ADDENDUM #5 INVITATION FOR BID #22-46

NEWTON FREE LIBRARY PARKING LOT IMPROVEMENTS

THIS ADDENDUM PROVIDES ADDITIONAL LANDSCAPE DRAWINGS AND CLARIFIES THE ANSWER FROM ADDENUDUM #3:

L1

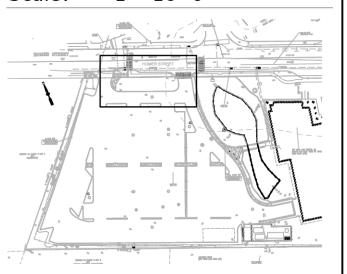
Q6. The planting schedule on drawing L1 has some different quantities than what is called out on all the landscape drawings. Some quantities are higher and some are lower. Since this is a lump sum item are we supposed to base it off the quantities in the planting schedule or the quantities called out on the drawings?

Replace plan set Sheet L1, Enlargement Plan 1, and Sheet L3, Enlargement Plan 4, with the attached updated plan sheets; changes made to the Planting Schedule table and Enlargement Plan 4 – Perennials as part of Revision No. 2 are clouded.

A6. The quantities for the planting should be based on the landscape drawings instead of the planting schedule.
